# DELRIDGE MIXED USE

SEATTLE DESIGN REVIEW BOARD

DESIGN RECOMMENDATION MEETING

8854 DELRIDGE WAY SW | PROJECT #3025313

2. NORTH FACADE AT GROUND LEVEL

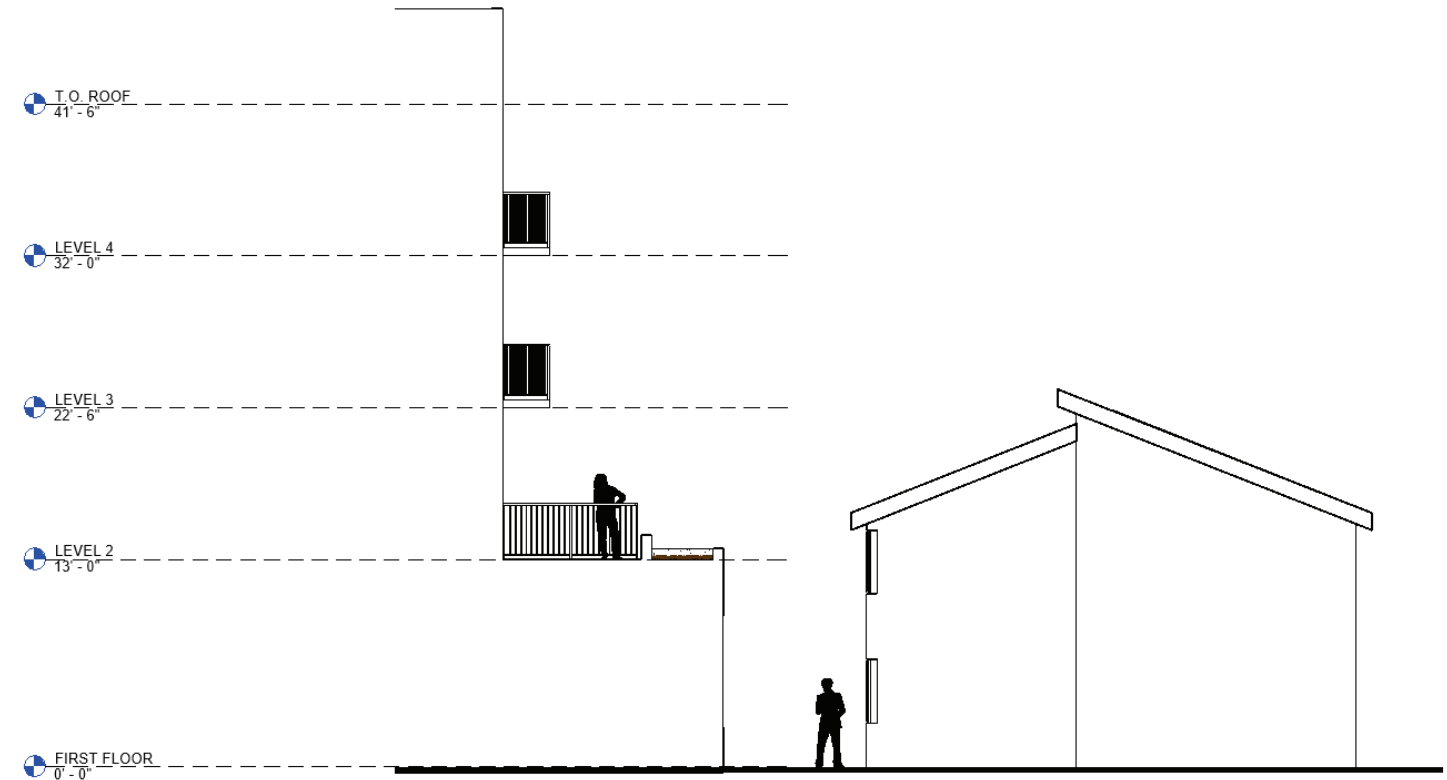
Staff is also concerned about the perceived height of the ground-level. The Board had also requested additional information regarding the design of the ground-level of the north façade and relationship to the adjacent residential structure. Please provide a privacy study depicting window overlap of the windows/openings on the north elevation of the proposed development and on the south elevation of the adjacent site; provide a street elevation that depicts the west elevation of the proposed development and adjacent site; and include the foot print of the adjacent structure in the site plan. Please include these graphics in the draft Recommendation Packet.

Privacy study diagrams show the adjacency of the North lot line building to the proposed structure North facing elevation and its overlap in respect to window openings. The setback on Level 2 deck as well as the greenery and plantings along the concrete wall of the proposed building provide sufficient visual and auditory buffer, as well as aesthetic appeal.

4. ALLEY PARKING & VEHICULAR ACCESS

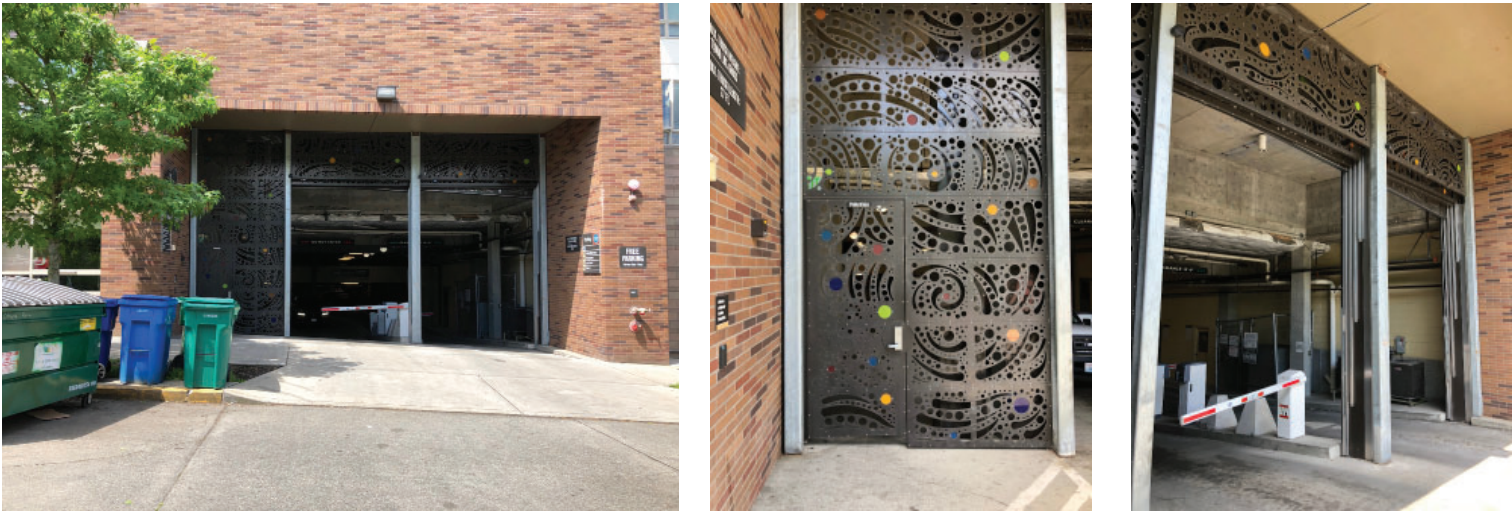
At the time of EDG, the Board was concerned about safety and security along the alley, particularly the ground-level parking area and garage access. The design should eliminate areas that may be used as shelter by non-residents. It appears the design of the ground-level alley façade is unchanged. Please further develop your designs in response to this guidance, and include additional information in the draft Recommendation Packet.

The Board had also requested additional graphics depicting the design of the ground-level alley-accessed parking spaces, its relationship to the alley and overall design, and how the space is intended to function. Please include these graphics in the draft Recommendation Packet.

Ground level parking area as well as the trash receptacle room have been added custom perforated screen doors. The screens at the parking area will be open during business hours and will close after hours and accessible through the screen gate door. Gated and secured entry will eliminate areas of potential unwanted shelter as well as add visual interest to the open spaces. Garage entrance door will have similar panels that will be roll-up.

Similarly proposed custom door images are provided for reference as implemented design.

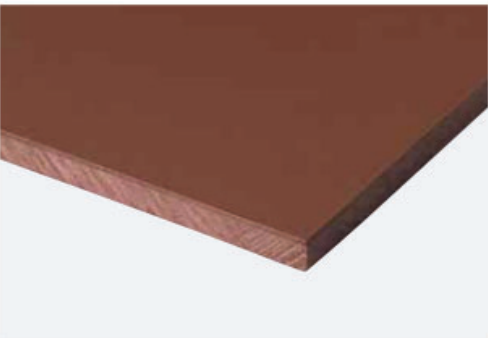
At the time of EDG, the Board had noted that - if used - fiber cement panels should be intentionally composed with an articulated pattern of reveals that relate to the overall architectural expression. As requested by the Board, please depict all material reveals in elevations and include details of material transitions in the draft Recommendation packet. This will also need to be depicted in the plan set.

Staff is concerned about the transition from brick to fiber cement panel. Indicate the depth of the transition and consider incorporating unique brick detailing at the transition.

The Board had also noted that if fiber cement panels are used, the material should be treated to age well in direct sunlight. Please explain how you have responded to this concern in the draft Recommendation packet.

- New material board has been developed to more accurately reflect the initial materials selection presented at the first EDG meeting.
- Materials treatment for the FCB panels is proposed to be geometric and reflective of the sawtooth concept. The cedar siding placement has been updated to wrap around the edge of the bay to further highlight the sawtooth pattern of the facade.

- Individual materials have been identified in colored elevations as noted.
- Fibercement panels have been placed in a geometric pattern to highlight and complement strong geometric concept of sawtooth pattern repeat. All reveals have been updated as shown on elevations.

- Transition from cultured stone to fibercement panels on same plane only happens at connection of FCP lap siding, which provided a smooth connection between horizontal planks and stone veneer.

- Proposed FCB panels are manufactured with color pigment mixed in at the time of panel manufacturing, which eliminated additional painting labor as well as making color more lasting and resistant to UV fading and color damage from the elements. FCB panels manufacturer is Cembrit or similar.

IRONWORK

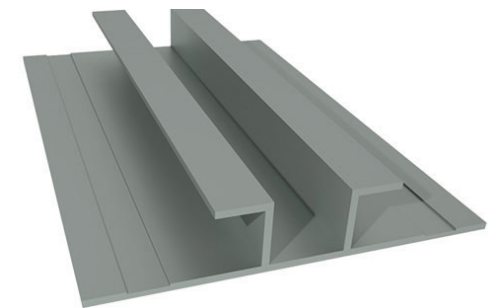
Please note, the Board had also noted the materials treatment should relate to the sawtooth massing concept and overall architectural expression. Consider how the cedar siding wraps the corner onto the south facade of each sawtooth bay. Please continue to develop the material palette in response to this guidance.

(A)  
Proposed metal balcony railing design

(B)  
Proposed metal railing at patio access area

(C)  
Proposed metal awning at retail and public entrances

(D)  
Fibercement Board reveal channels

6. DESIGN ELEMENTS

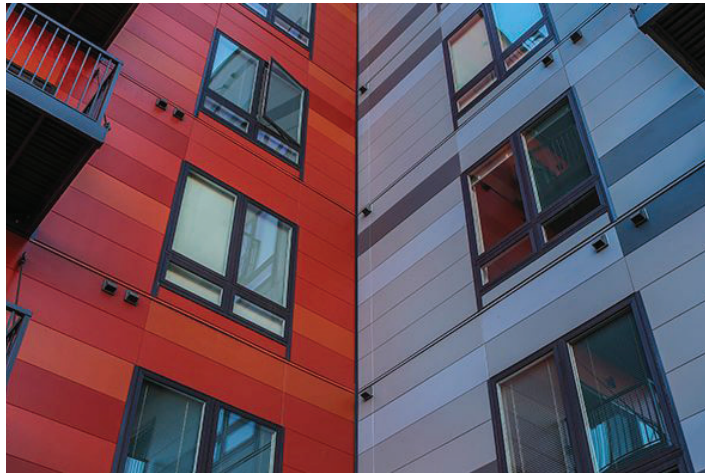
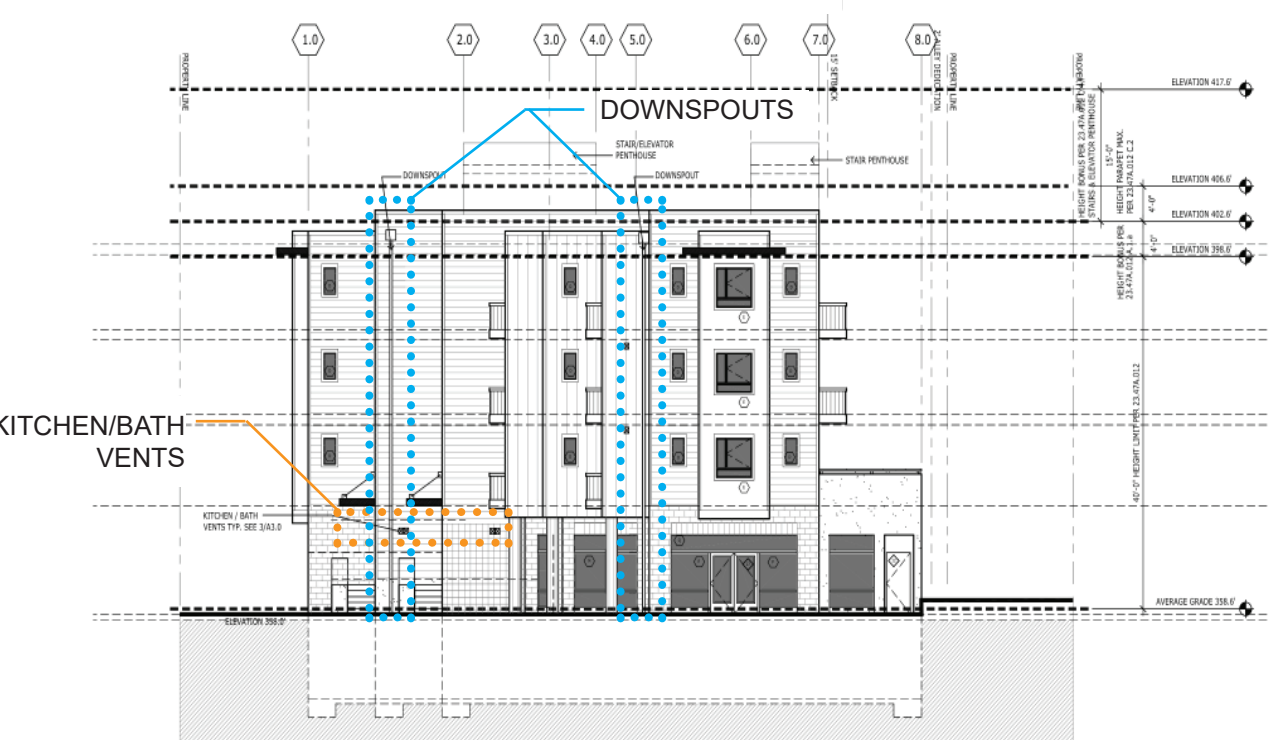
At the time of EDG, the Board had requested additional information pertaining to the façade composition, secondary elements, and materiality at the Recommendation phase. Include vents, downspouts, mechanical systems, louvers, etc. in drawings in the draft Recommendation packet and MUP plans. Include precedent images of balconies, trellises, etc.

The Board had supported the proposed use of a perforated roll up garage door. It is unclear what type of garage door is proposed in the plans. Please call out.

Concept images for the facade composition details have been provided.

Cedar plank to FCB panels transition at the entry to the street level units with unit numbers

Balcony railings design

Street entry unit entry and Level 2 deck/patio railing design

Vents placement at CFB horizontal panels

Gutter design at FCB

Metal awning over commercial entry and main units entry

DESIGN DEPARTURE

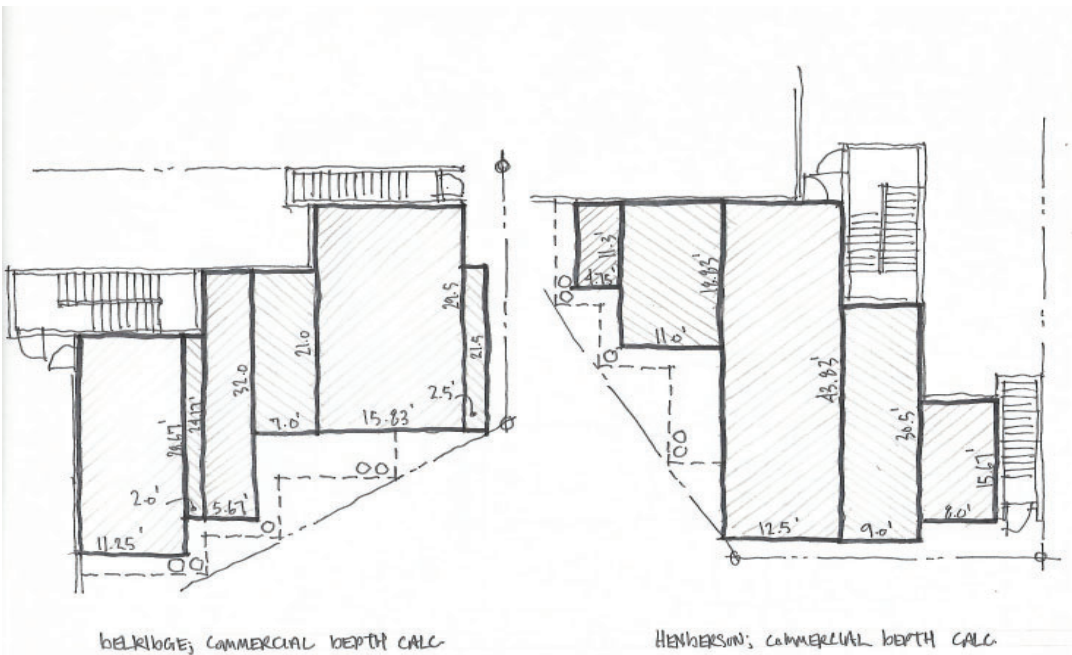
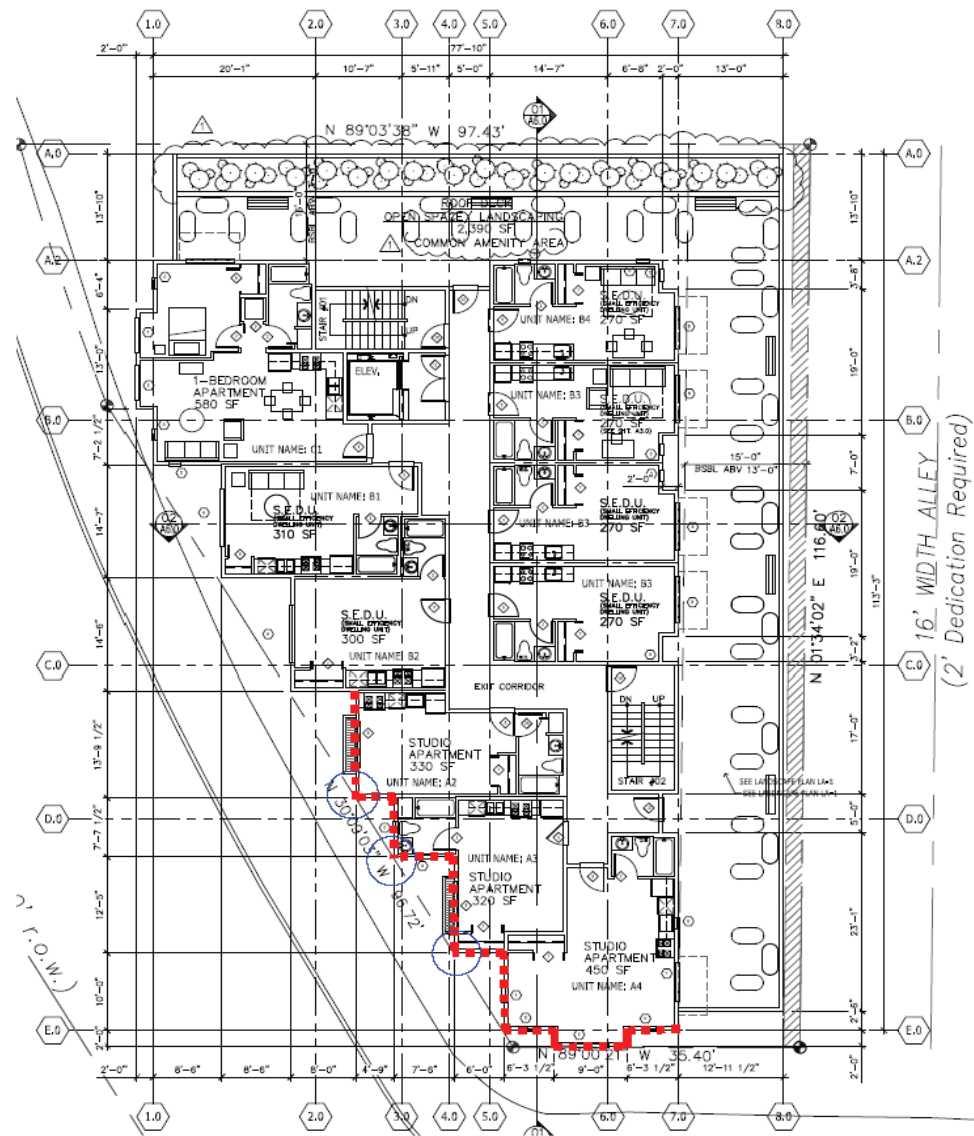
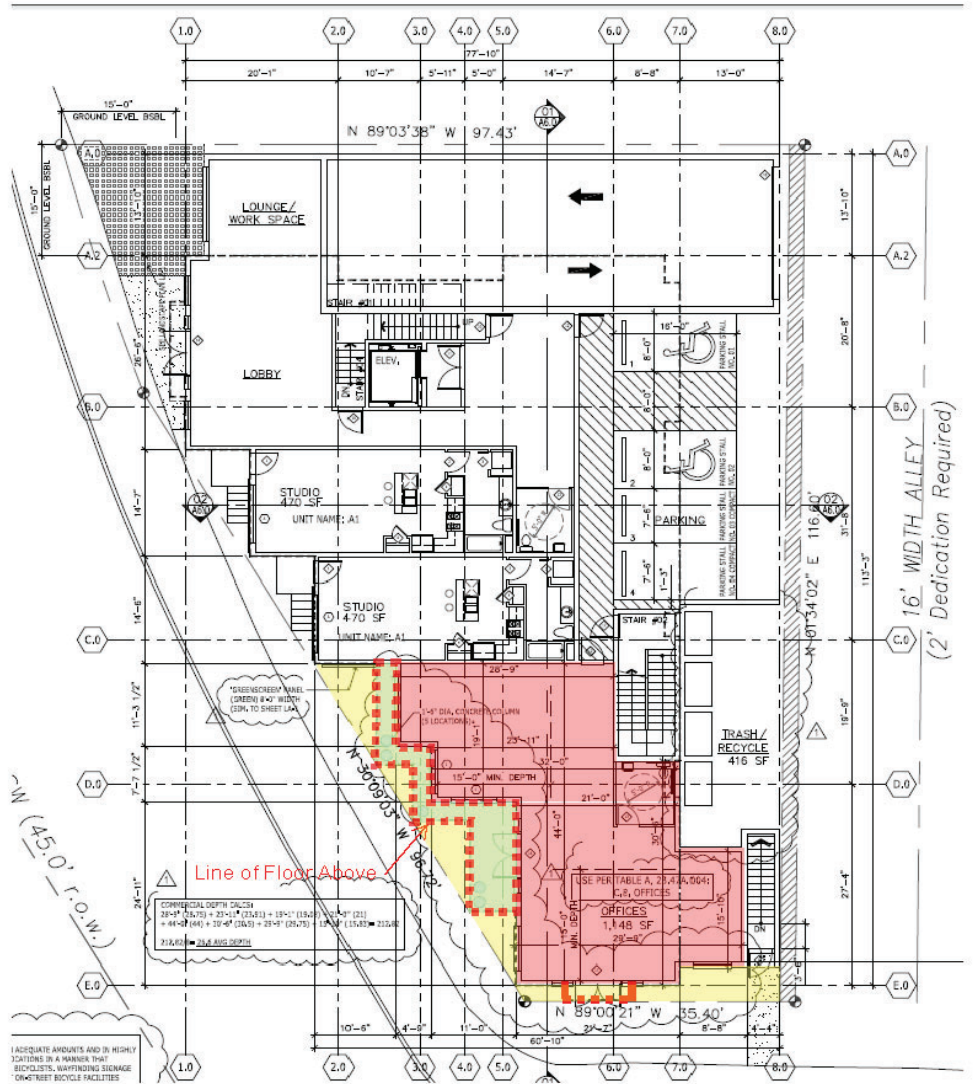
23.47A.008 STREET-LEVEL DEVELOPMENT STANDARDS B.3

Depth provisions for new structures or new additions to existing structures. Non-residential uses shall extend an average depth of at least 30 feet and a minimum depth of 15 feet from the street-level street-facing facade.

Currently, our proposal has a depth of 26.8’ measured from Henderson and a depth of 27.8’ measured from Delridge with some portions along Henderson under the 15’ minimum. Consequently, we are seeking a Design Departure to satisfy this requirement.

The concept brought forward at the Early Design Guidance meeting was a Zig-Zag façade along the street sides of the building facing Henderson and Delridge because of the triangular shaped lot.

In an effort to maximize this Zig-Zag concept the points of the Zig-Zag at the two Residential Levels have been pushed to the property line (see Diagram 2). The Commercial Level however has been set back slightly to provide some relief for pedestrians from the busy street by creating a modest plaza space. This in turn also provides protection from the weather as pedestrians approach the building (see Diagram 1). We also feel setting the commercial level back from the street gives the building more of a human scale. This recessed entry makes the building more approachable and less imposing. We have included some oversized columns to support the Residential Levels above to provide an added architectural detail and also act as a buffer to the street for the commercial space. To meet the commercial depth requirement would could push the commercial level out to the same plane as the residential levels above but feel this would not be as elegant solution.
